1704 Latton Water Treatment Works Tender Change Control Tracker

Issue 01 - 25 April 2025 (work in progress issue)
Issue 02 - 02 May 2025
Issue 03 - 02 May 2025

project	1704	project	Latton Water Treatment Works
document	D07 - 03	title	Tender Change Control Tracker
issue date	02/05/2025	scales shown @ A3

1. Amend wall build-ups to suit structural design.

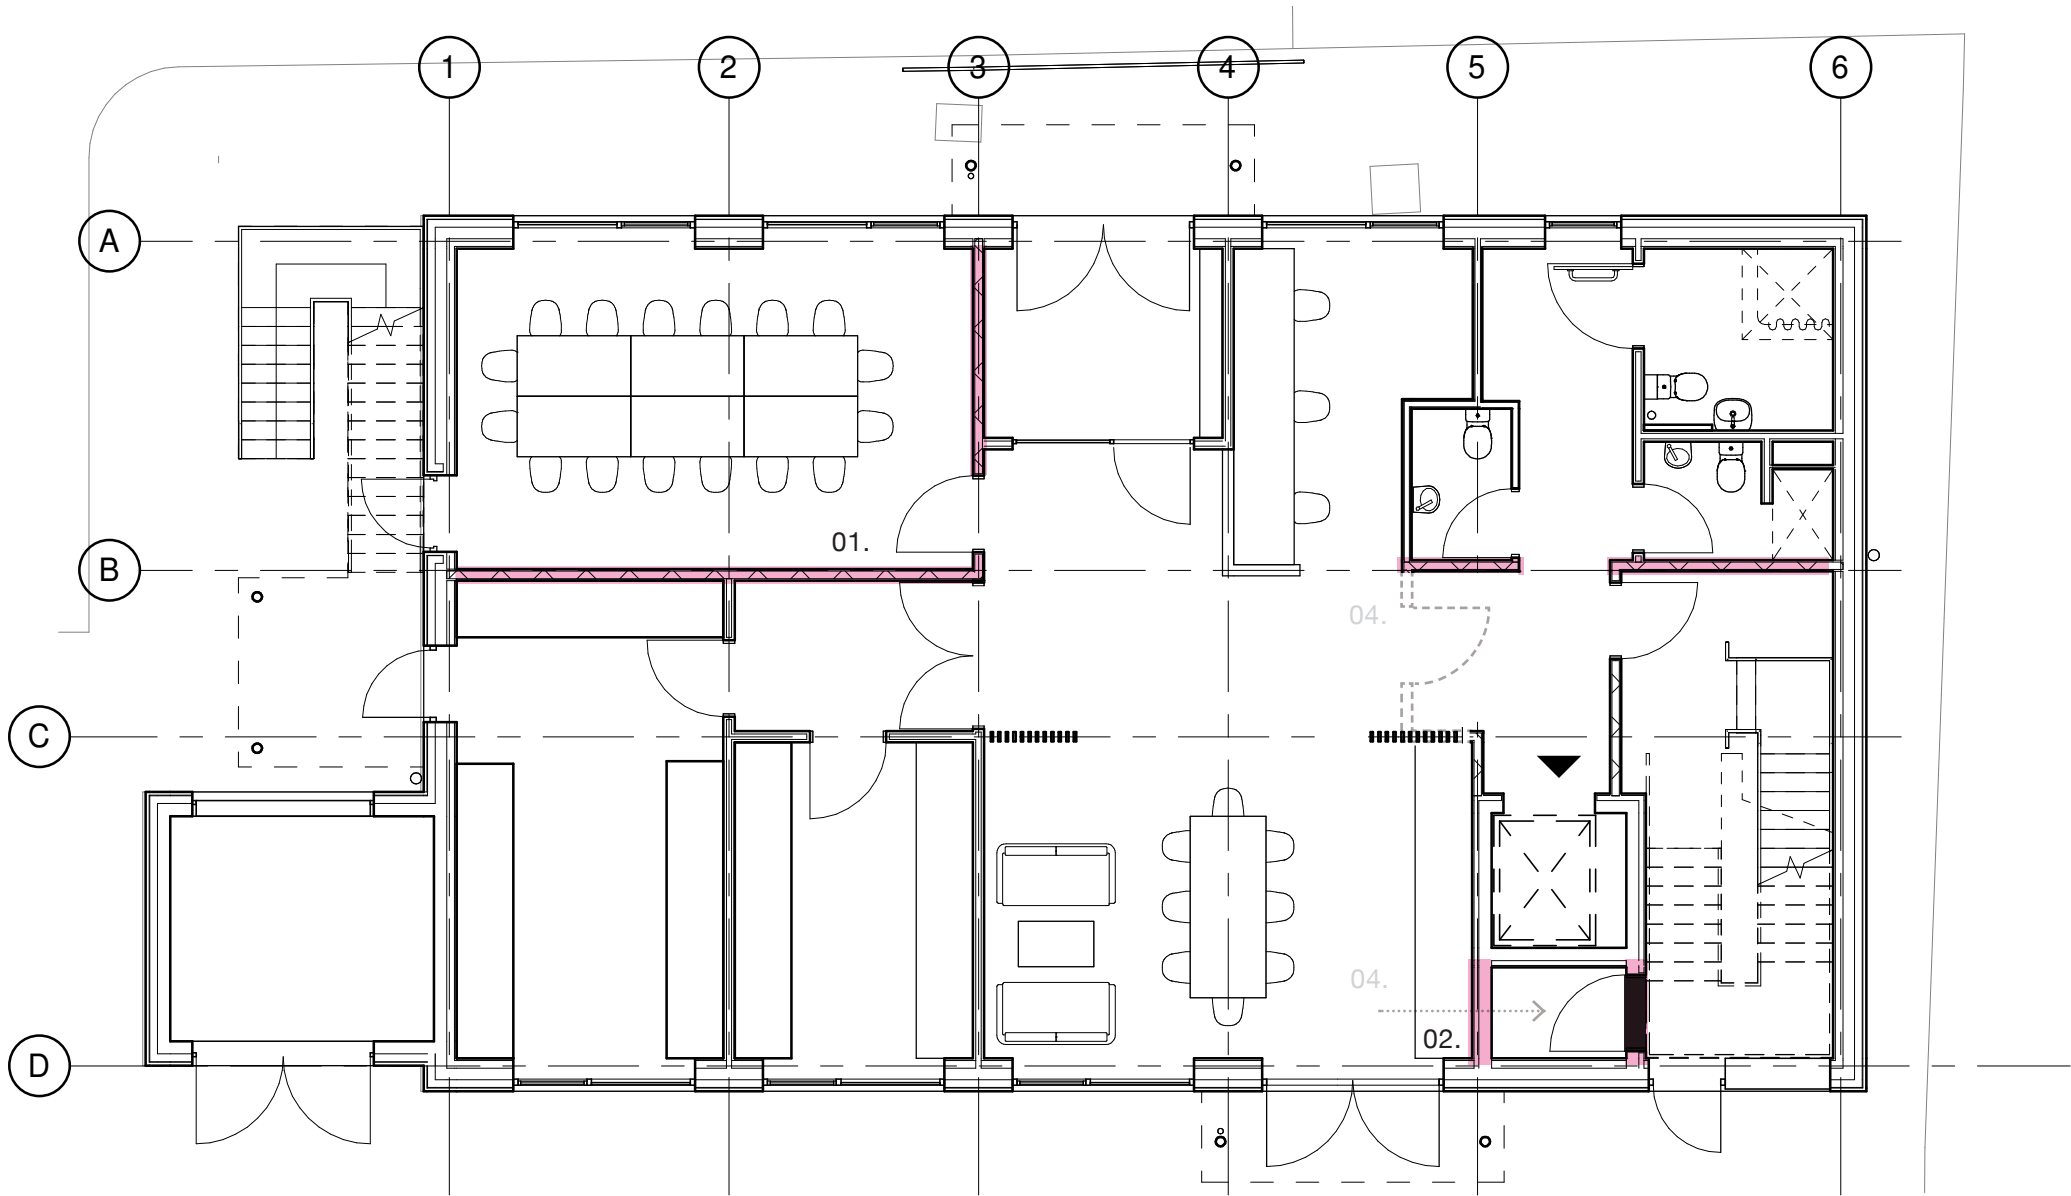
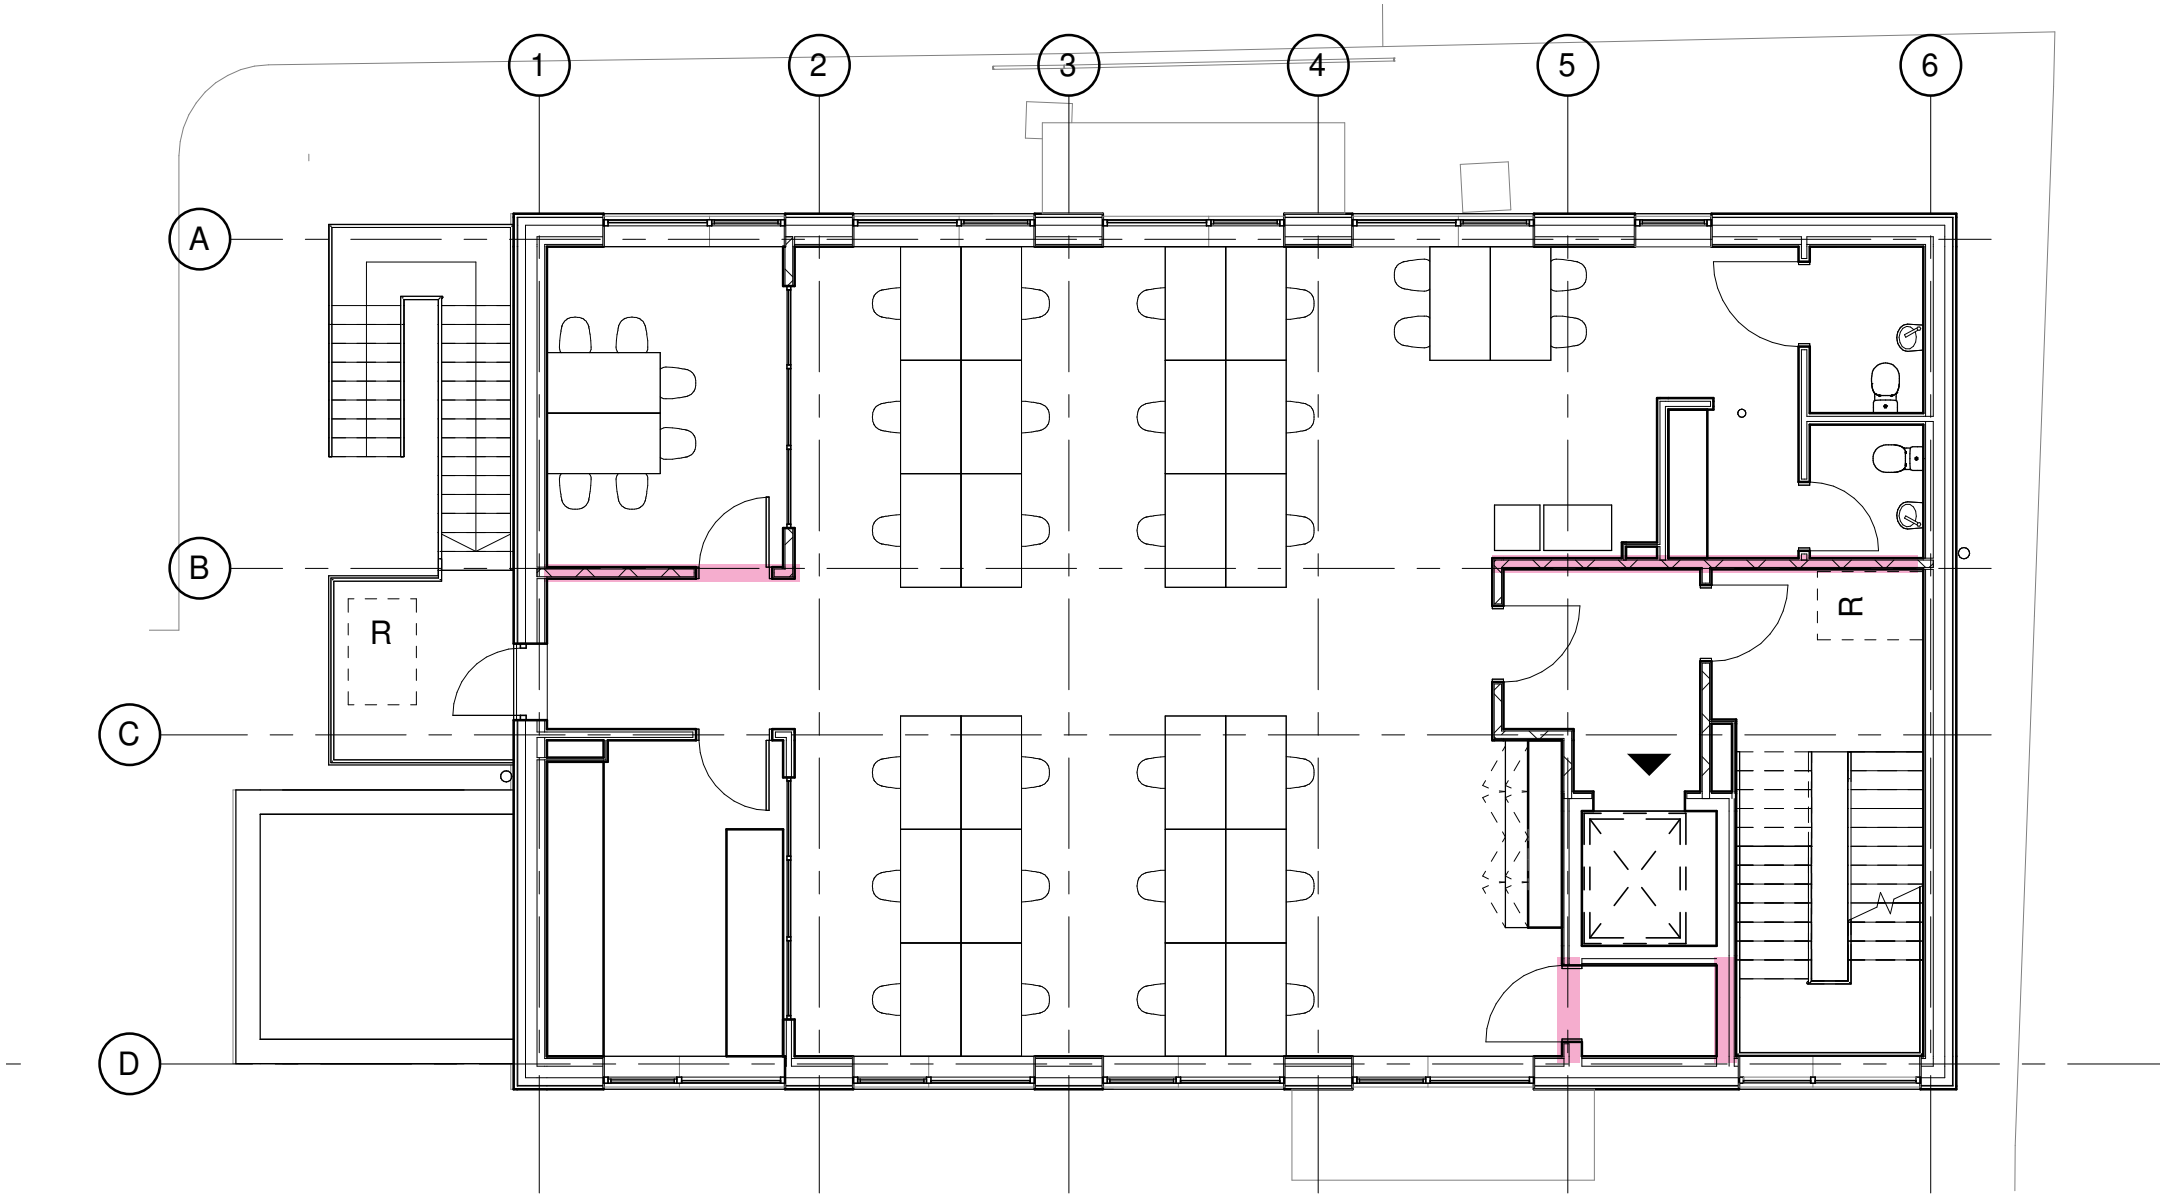
- 01. Change central spine wall to 140m blockwork and review setting out implications.
- 02. Change cleaner’s store wall construction and review setting out implications.
- 03. Full review of structural design to be completed.
- 04. To be read in conjunction with amendment 6 and 7.

Structural design.

Change agreed 31/03/2025.

2. Anti-slip walkway to be added to roof plan.

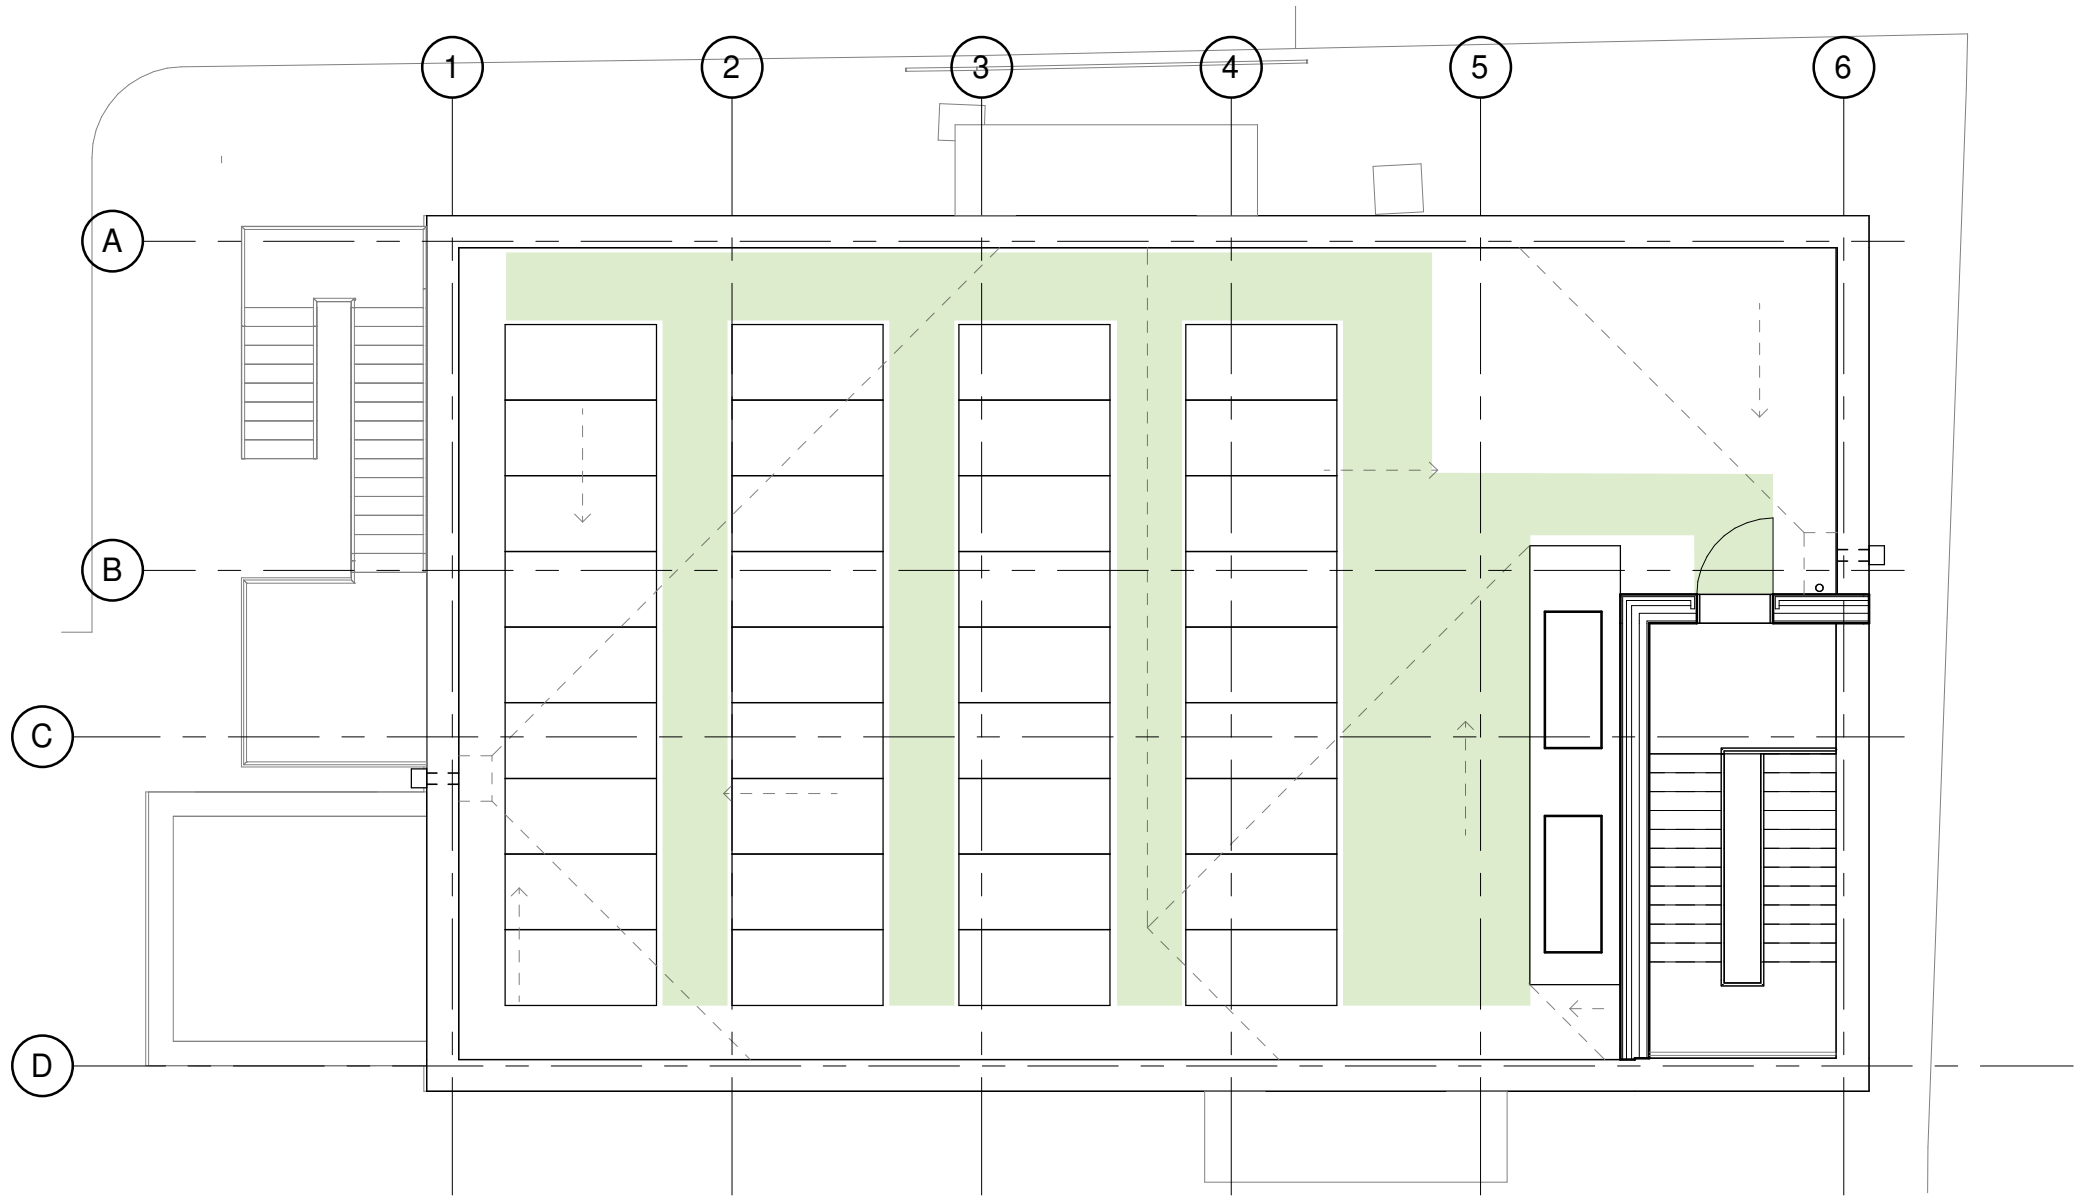
- Potential amentment**
01. Add anti-slip walkway to roof - shown in CS2 finishes information.
- Reason for change**
Client instruction.
- Affected design information**
1704-1063 Setting Out Plan - 02 Roof Plan
- Design decision**
Change agreed 31/03/2025.

4. Footpaths change to concrete.

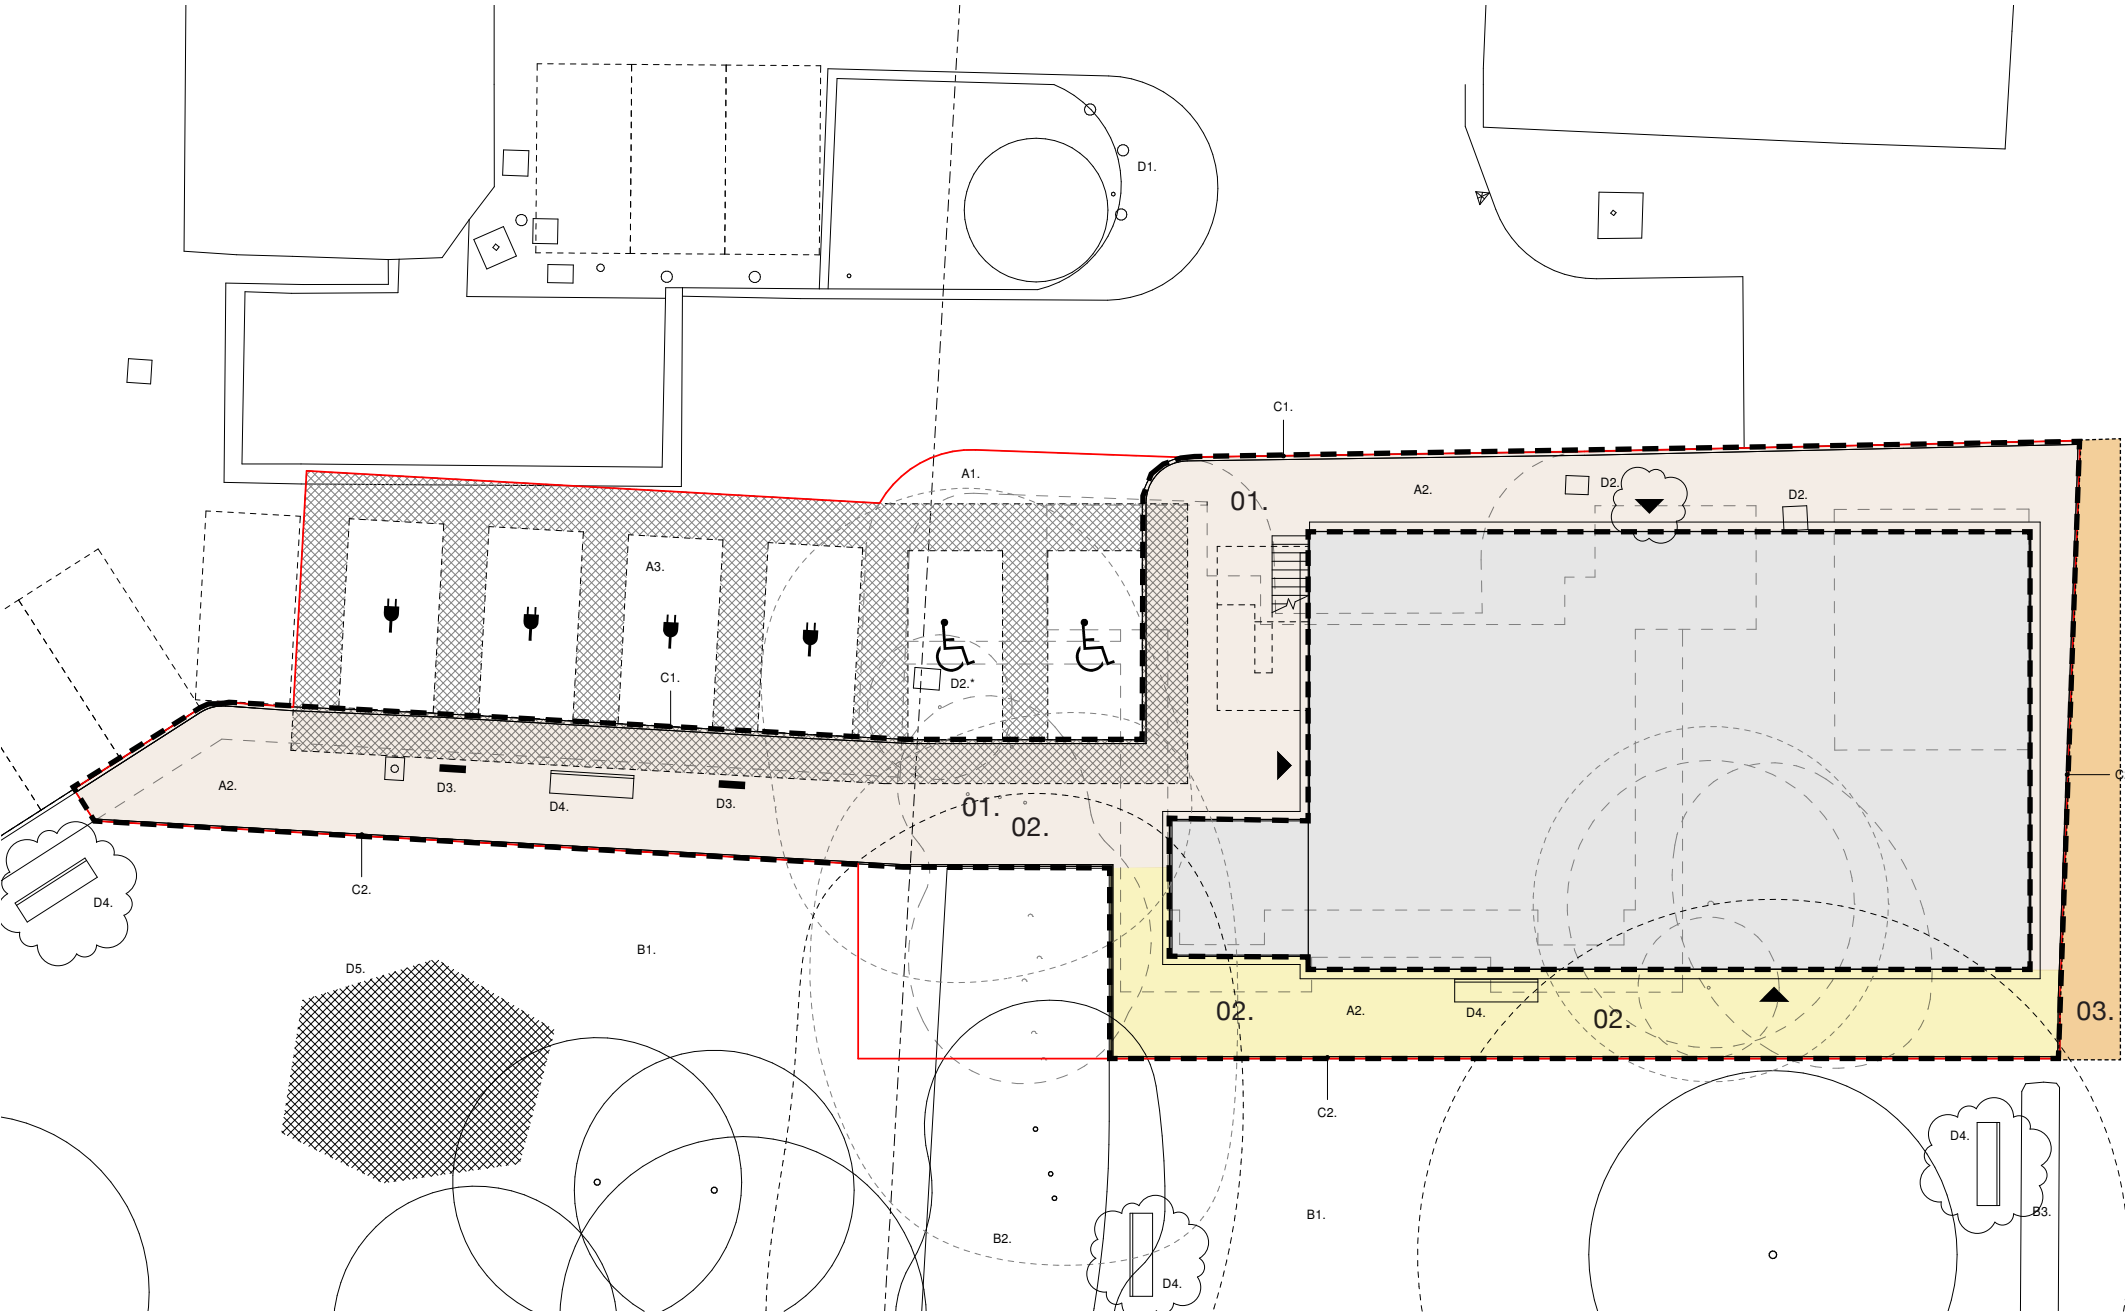
- 01. Footpath surfacing to be amended to brushed concrete where adjoining vehicular areas and to S.E side of building.
- 02. Permeable resin-bound gravel from plant room to rear of building to reduce impact on trees.
- 03. To be read in conjunction with amendment 13.

Client instruction.

Change agreed 31/03/2025, updated 02/05/2025.
